From: Emily Wade <Emily.Wade@midsussex.gov.uk>
Sent: 16 April 2026 15:27:05 UTC+01:00
To: "Katherine Williams" <Katherine.Williams@midsussex.gov.uk>
Subject: RE: DM/26/0156 and DM/26/0213 - Heathfield House, High Street, Cuckfield

Subject: DM/26/0156 and DM/26/0213 - Heathfield House, High Street, Cuckfield

The Talbot Hotel and Cuckfield High Street in the 19th Century

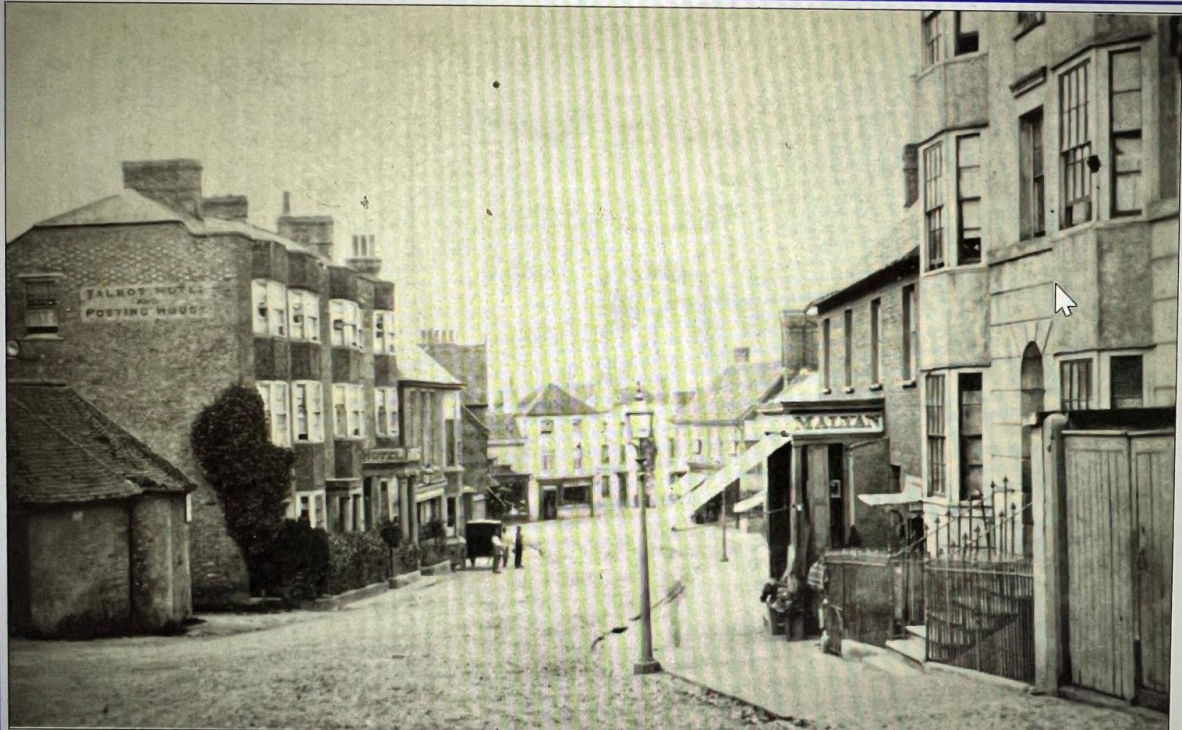
- The external photograph dated 1875 is suggestive, but does not (obviously) show the internal layout of the building. For example, it is possible that the house door was moved across to make way for the shop front as suggested, but this does not necessarily mean that the width of the hallway behind it was altered.

Similarly, the wall to the left upon entering through the repositioned front door appears to be a later addition. Historic evidence (as shown in the attached image) indicates that the original entrance was centrally aligned with the upper windows. The relocation of the door to its current off-centre position likely occurred when the shopfront was introduced, necessitating internal reconfiguration. This wall therefore seems to have been inserted to accommodate those later changes, reducing the scale of what would originally have been a principal reception room. By removing this wall I am simply opening the room up to its original form.
